Determination 2022/002

**Regarding compliance of as-built timber retaining walls
with the Building Code as it relates to the protection of
other property**

67 Waratah Street, Matua, Tauranga

Figure 2: Typical cross-section through retaining wall Types 4 and 5 (not to scale)

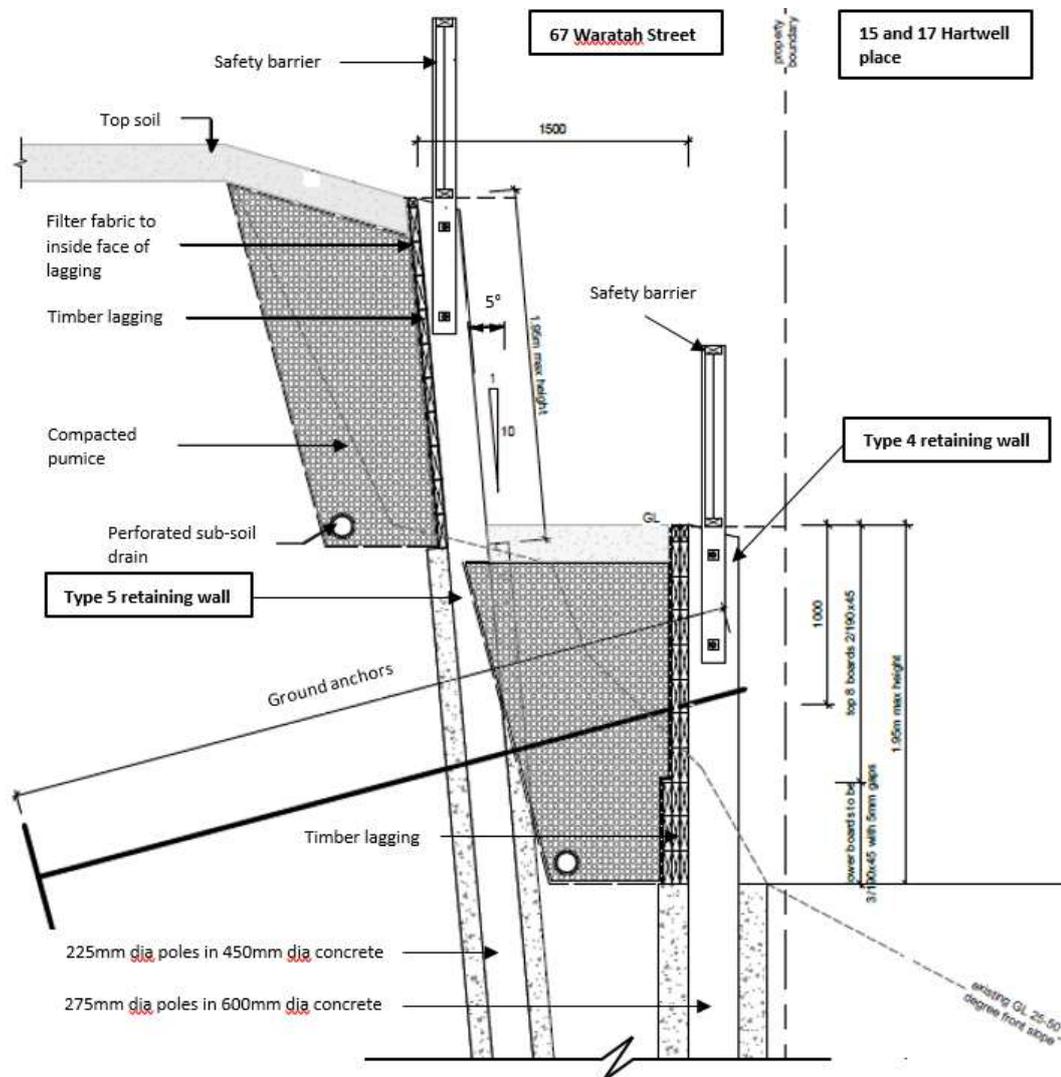
(Note: the original design specified the poles were to be spaced 1200mm apart, and the ground anchors were to be 25mm in diameter)

- 7.20. The original building consent plans do indicate a slope of between 25 to 50 degrees below the Type 4 retaining wall (refer to figure 2). Although the as-built plans did not indicate an angle for the slope they do note that the approximate ground level varies.

Figure 8: Easterly view

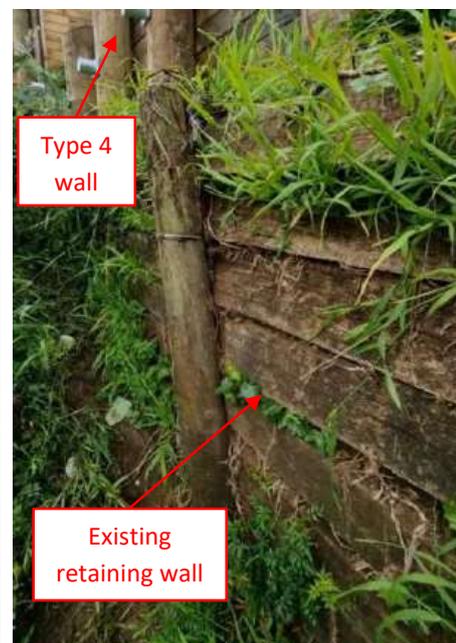
5.10.4. The existing wall “varies in its degree of deterioration”. This included that some of the timber “poles had rotated inward, while others had rotated outward”, and the “horizontal lagging was observed to follow the rotation of the...poles”. See figures 7 and 8.
